## **Safety Defect and Noncompliance Report Guide for Vehicles** **Part 573 Defect and Noncompliance Report**

Re: Atwood Mobile Products  
Part 573 Defect and Noncompliance Report – Sealed Burner Tube Recall

Re: Recall of burner tubes on Atwood Sealed Burner Appliances

#### INSPECTION AND REPLACEMENT INSTRUCTIONS FOR BURNER TUBES ATWOOD SEALED BURNER COOKING APPLIANCES

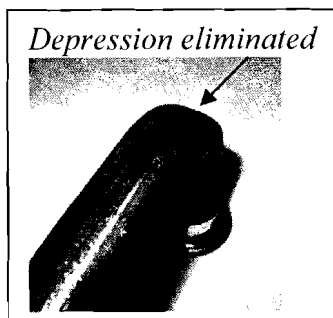
*The Range and Slide-In burner tubes leading from the gas manifold to the burner heads had a depression or 'kink' in the exterior bend restricting proper airflow and gas mixture.*

*Atwood Quality Assurance report QA7091 on March 28, 2007, revealed the following carbon monoxide levels:*

- left rear burner 1010 ppm
- right rear burner 987 ppm

*The depression or 'kink' on the exterior radius of the bend point on the burner tube is nearly eliminated.*

*Burner tube tooling was corrected by polishing the bending surfaces on April 6, 2007, along with establishing a preventative maintenance schedule for the tooling.*
